DA No 201835109

BLOCK:	SECTION:	DIVISION:
21	30	Dickson

DESCRIPTION OF THE PROPOSAL: MIXED-USE COMMERCIAL AND RESIDENTIAL DEVELOPMENT - Proposed demolition of existing structures, removal of regulated trees, construction of a mixed-use development up to seven storeys, including 140 residential units; a supermarket and other retail/commercial tenancies on the ground floor; podium level car park; two levels of basement car parking; ancillary rooftop structures; landscaping and associated on-site and off-site works.

drawn	ZG	service	ELECTRICAL SERVICES
date	16.11.18	title	NEW SITE SERVICES PLAN
designer	SG	scale	1:400@A1
date	16.11.18	project no	S4B18006500
scale	1:400@A1	drawing no	E-002
			rev P2

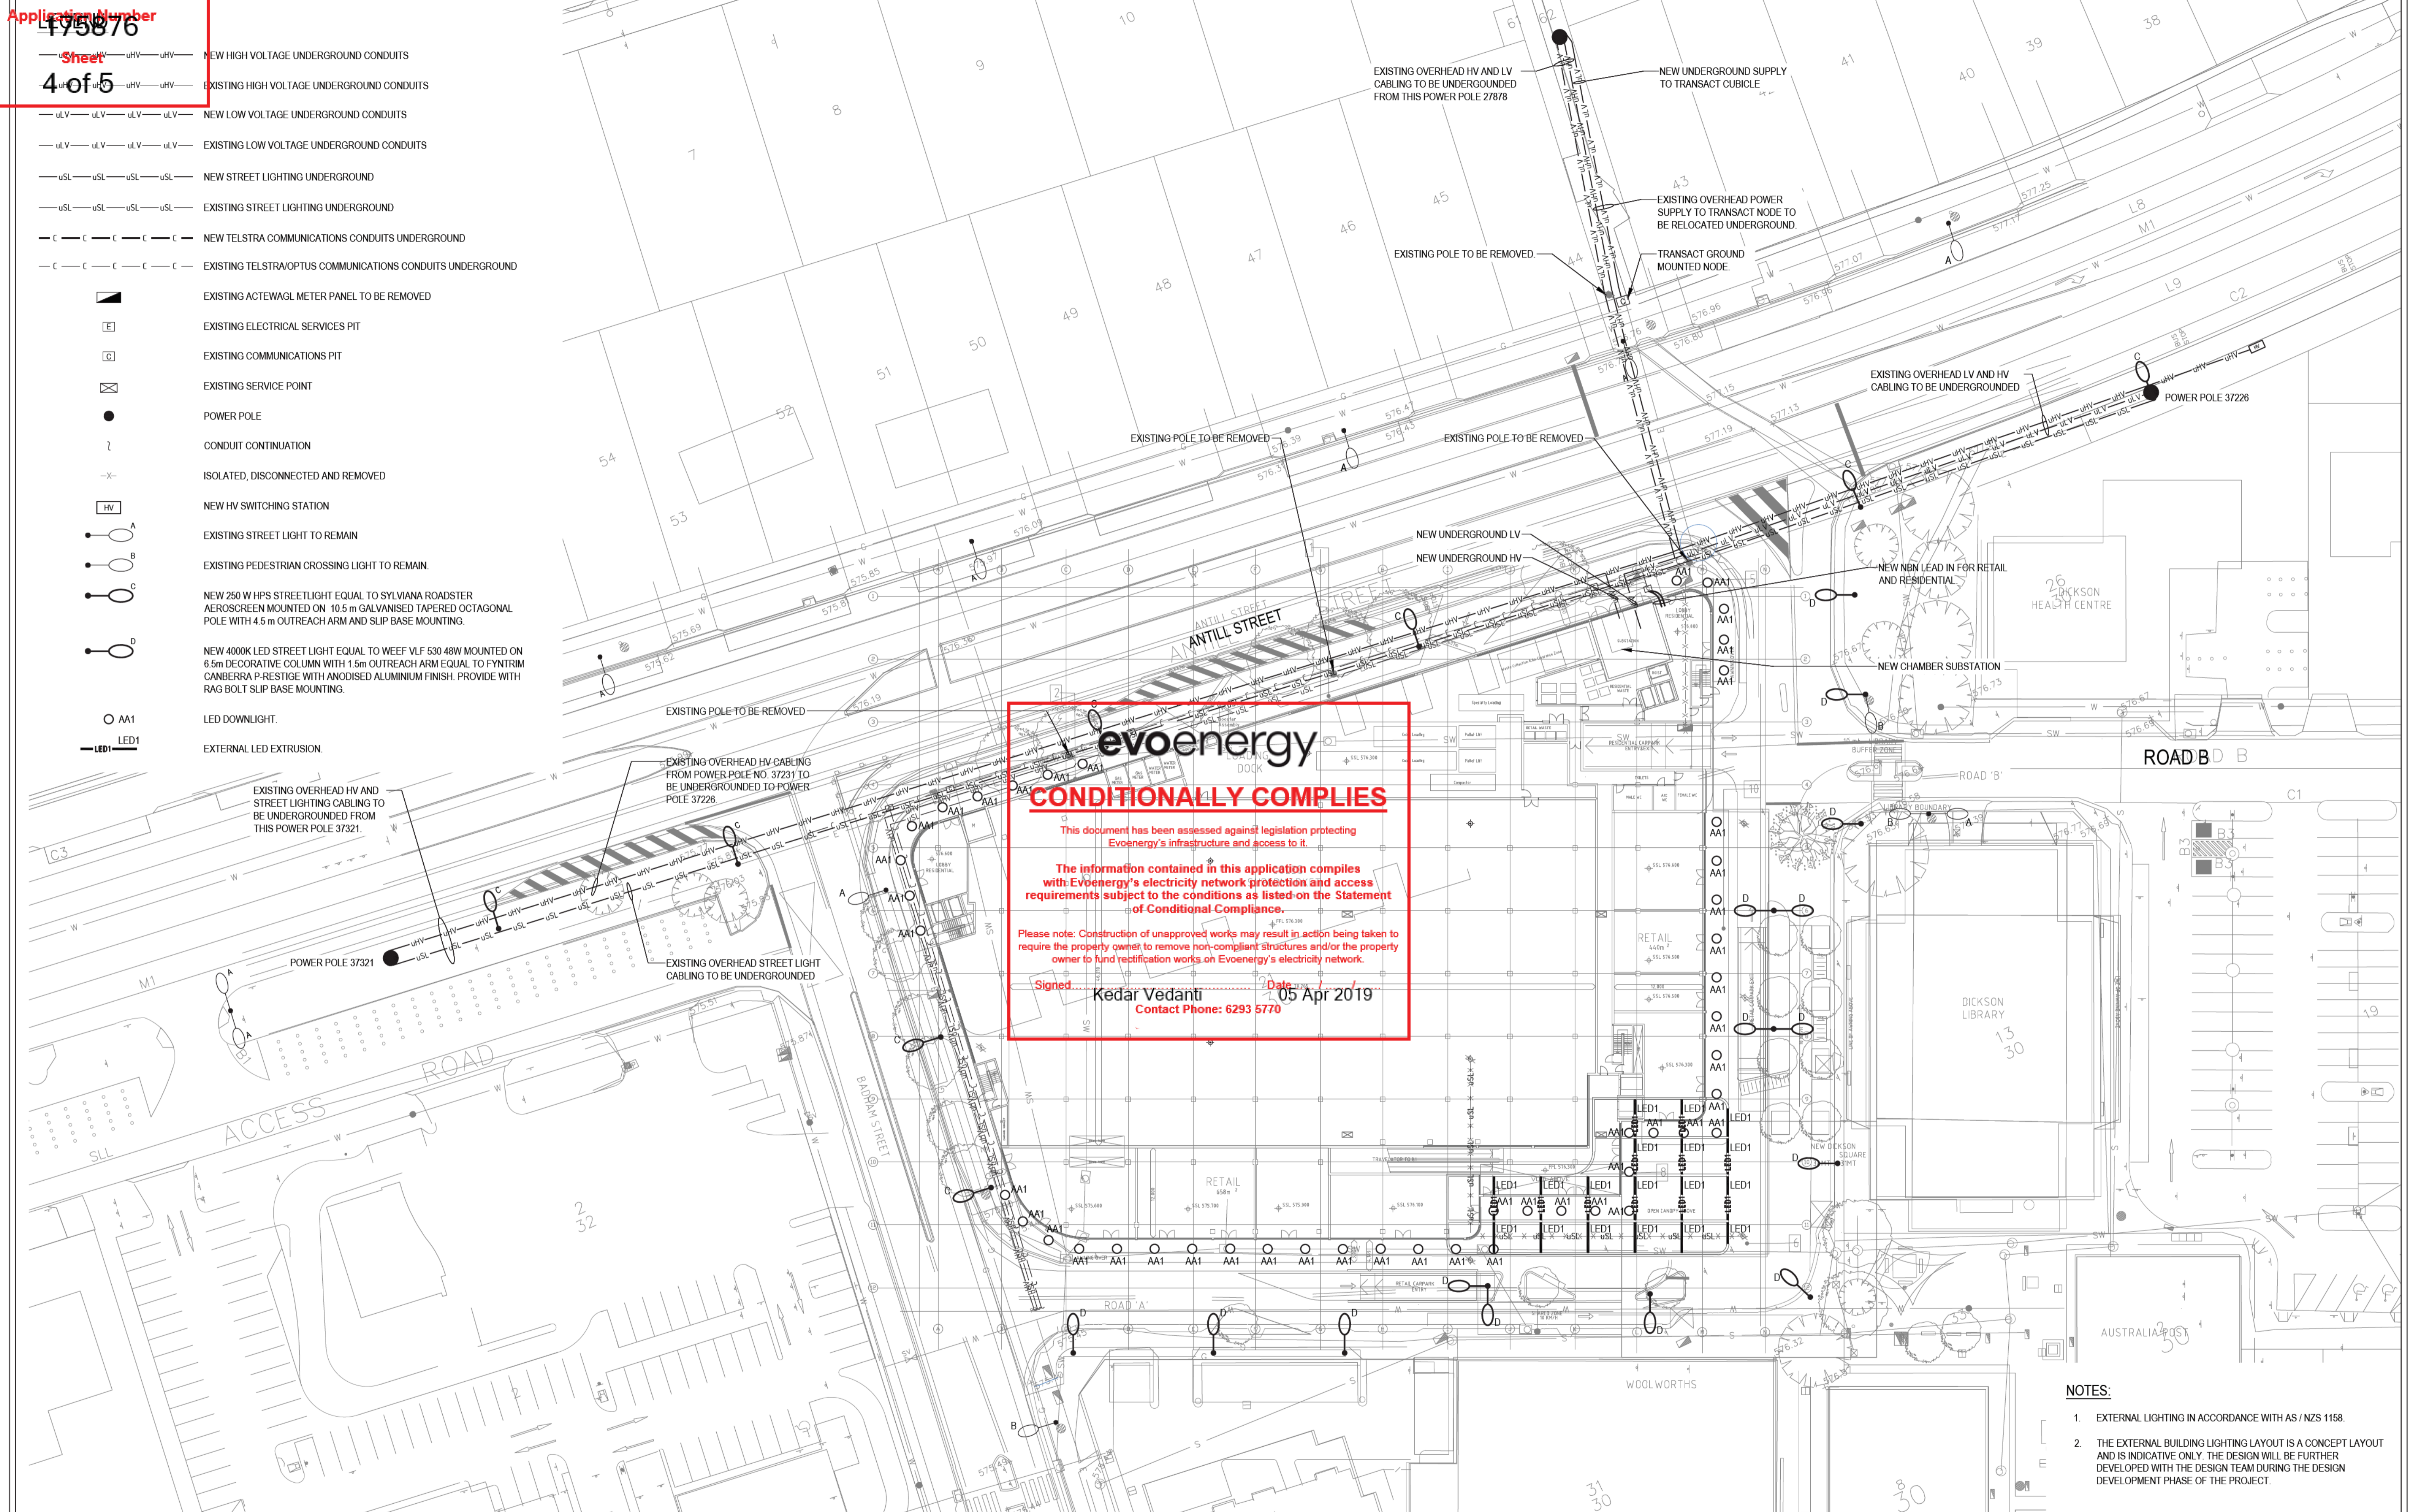
An area for a Substation needs to be allowed for on the block/s. This area will be determined by Evoenergy when the proponent submits the electrical load of the development. The area will be 7.0m x 5.0m for loads within 1MVA. If the load exceeds 1MVA a Chamber Substation will be required. Evoenergy may determine that twin padmount substations with an area of 9.0m x 7.0m will be installed if the load does not exceed 2MVA.

Development is to comply with minimum 1.5m machinery access clear of obstacles and vegetation to assets within the block.

Development is to comply with minimum clearances to overhead conductors and poles. Ref Evoenergy Drawing 3811-004

Development is to comply with minimum separation requirements to underground assets. Ref Evoenergy Drawing 3832-018

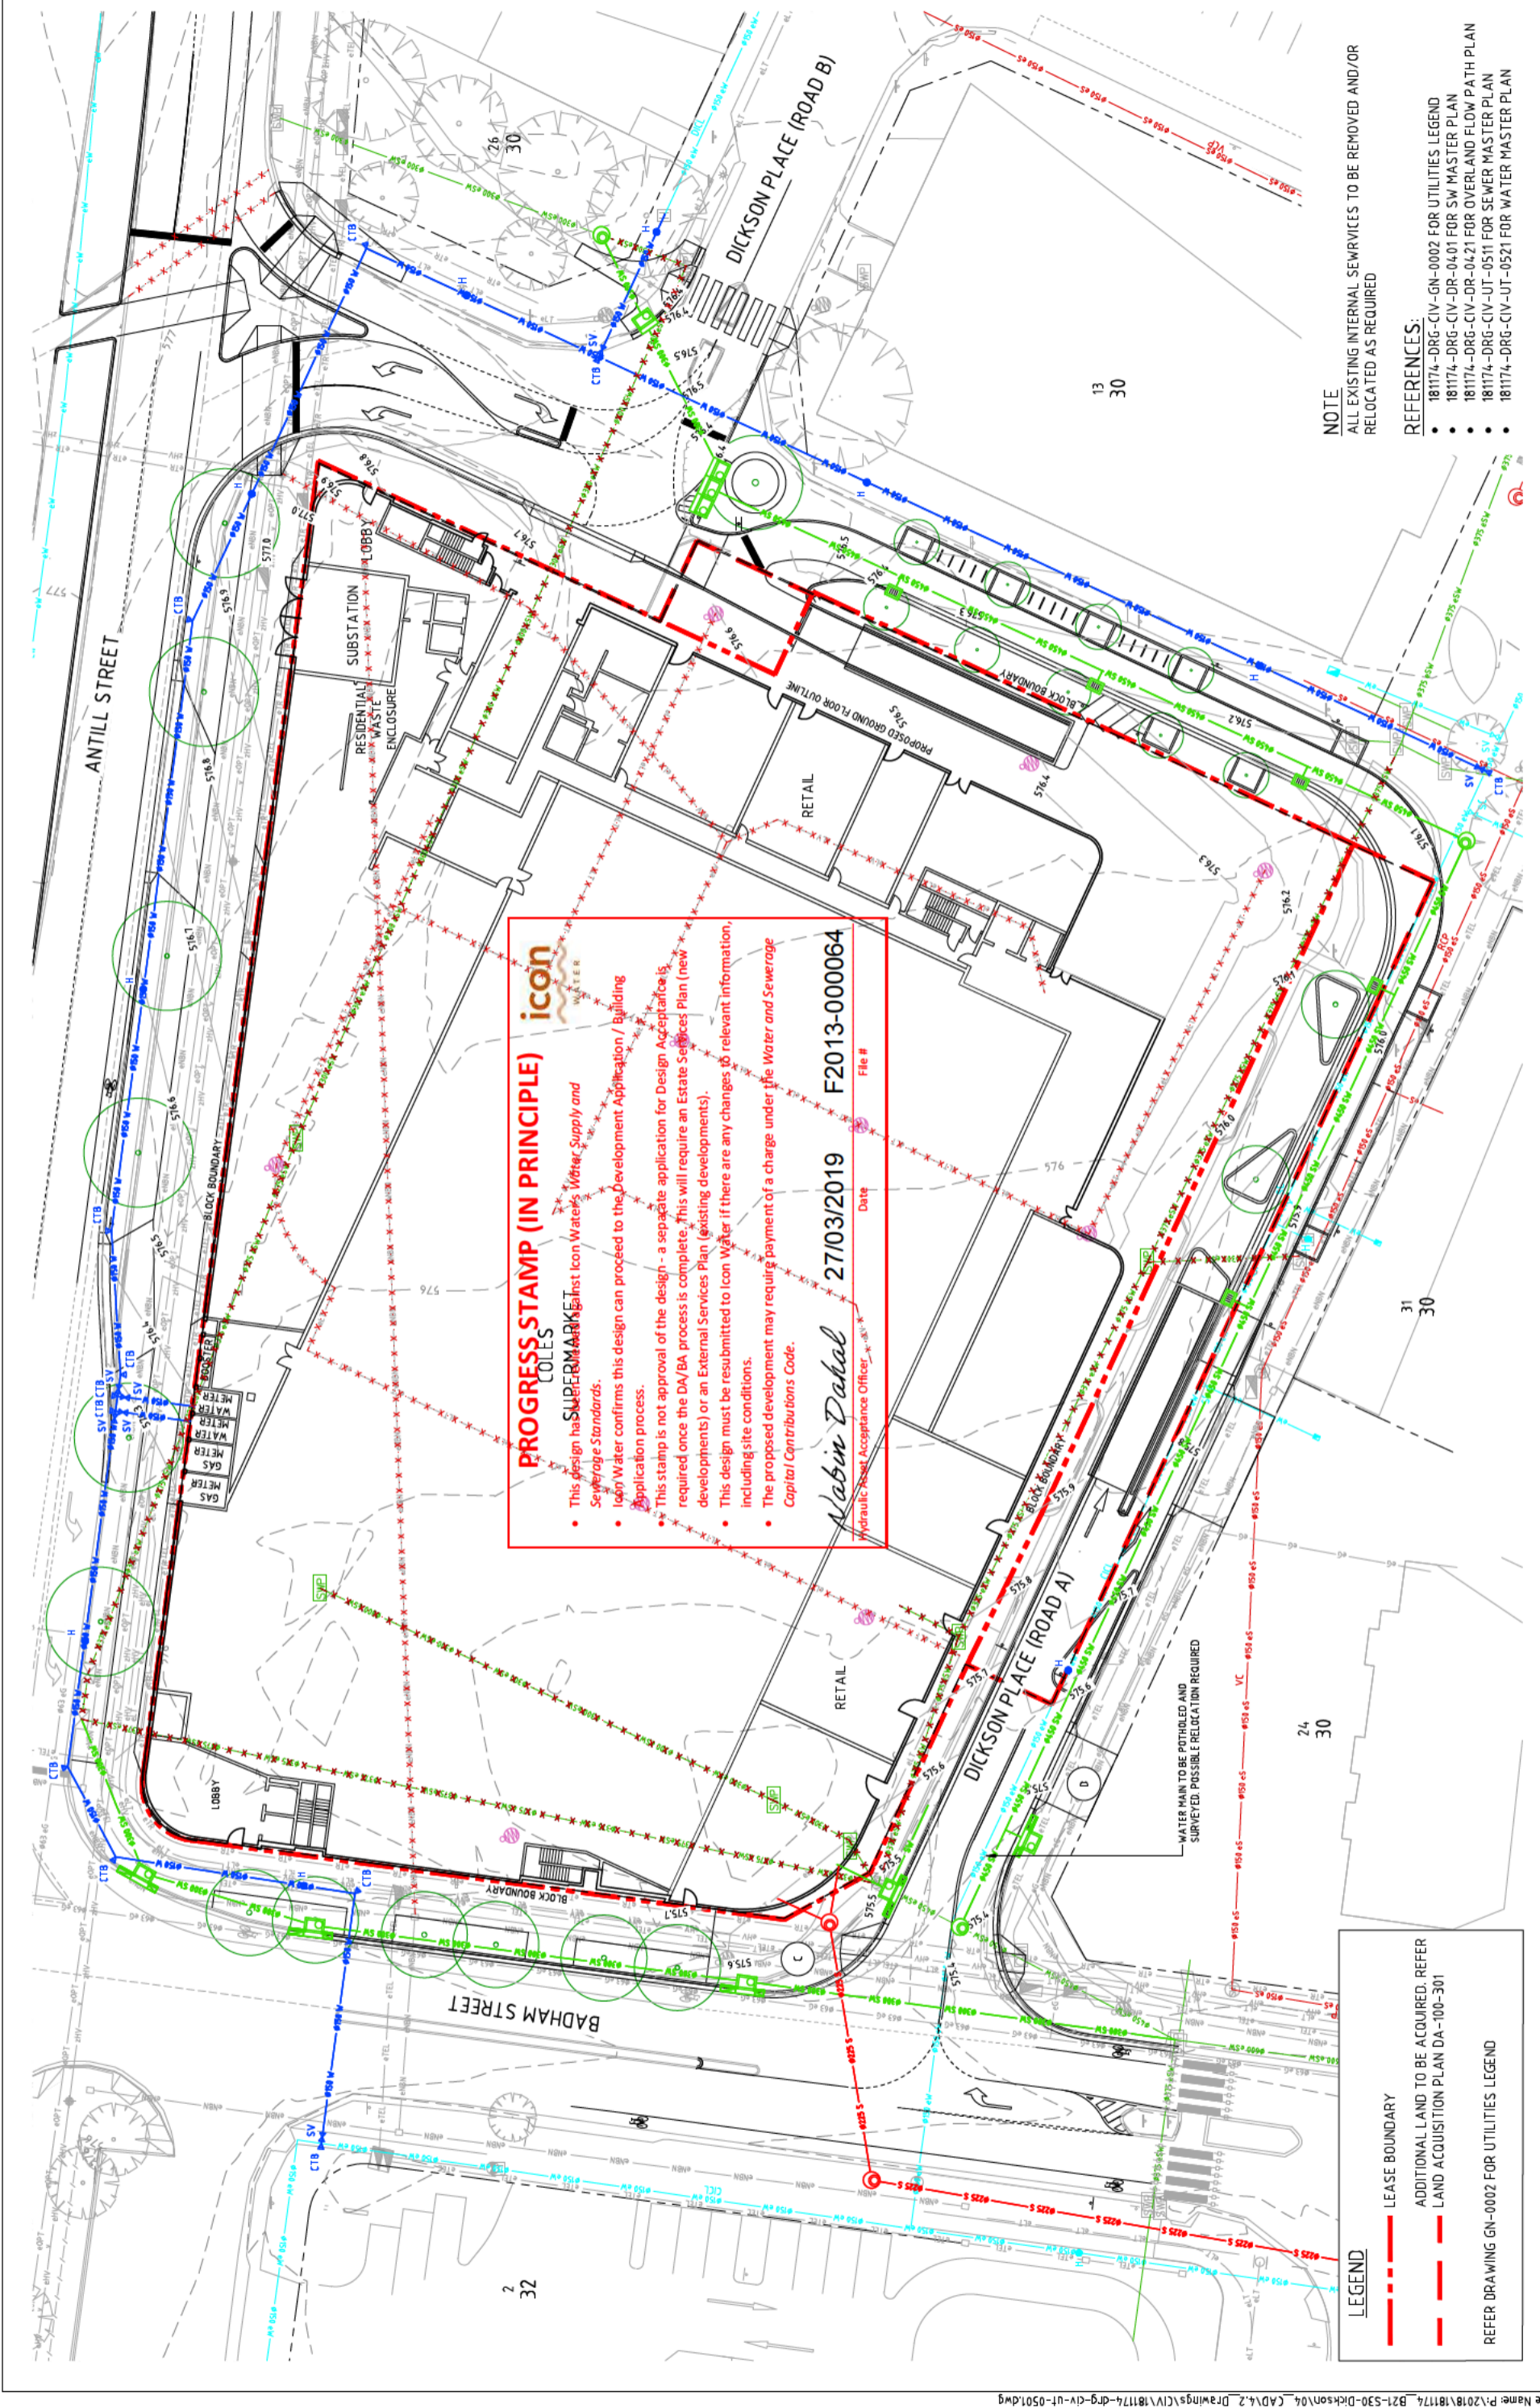
On 3 April 2019, the ACT planning and land authority sought further Council comment on the proposed development, and specifically on proposed repaving of the road verge between Blocks 21 and 13 and part of Block 13, as illustrated on the project's 'Ground Level Paving Plan'.

The proposed new paving (as shown on the 'Ground Level Paving Plan' L-DA-15) terminates at a splayed alignment from the north-east corner of the Woolworths building to the south-west corner of the library. The Council considers this junction line between new and old to be inappropriately located also because it does not relate to existing features of the Library.

As the setting of the Library is identified in the ACT Heritage Register entry as a significant feature of the place, the Council identifies the following heritage condition in response to the paving proposal:

- There should be a consistent approach to paving within Block 13, particularly to the west and south of the Library; and the paving used within Block 13 should complement the heritage significance of the Library.

The Council considers that this could be achieved by excluding Block 13 from the repaving proposal; or by extending the repaving proposal to include the entirety of Block 13.
